# Install Butyl Rope On Lower Rear Doors

**Classification** Repair Bulletin      **Section/Group** 11 - Closures      **Country/Region** All

**Year** 2015-2018      **Model** Model X      **Version** All

*This Service Document supersedes SB-18-11-002, dated 2-Mar-18. Each content change is marked by a vertical line in the left margin. Discard the previous version and replace it with this one.*

**Figure 1**

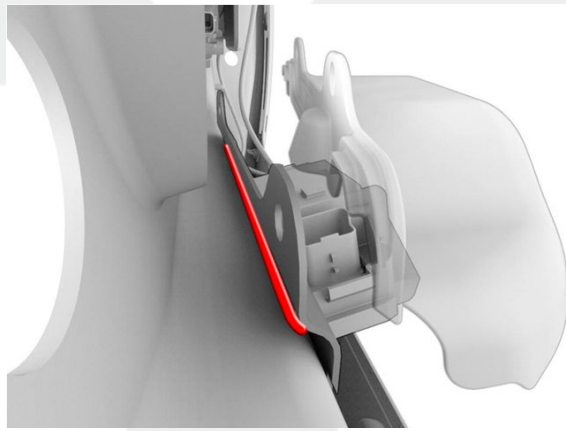
1. Use a utility knife to cut 2 10 in (26 cm) long pieces of the butyl rope.
2. Remove the rear door trim panel (refer to Service Manual procedure 15132001).
3. Remove the rear door speaker.
4. If a rear door latch shroud is not currently installed, install a rear door latch shroud on the LH and RH side. Refer to SB-18-11-002, "Install Rear Door Latch Shroud".
5. Use isopropyl alcohol to clean the area between the latch reinforcement and the inner door skin.
6. Apply the butyl rope to the area between the latch reinforcement and the inner door skin as shown (Figure 1).
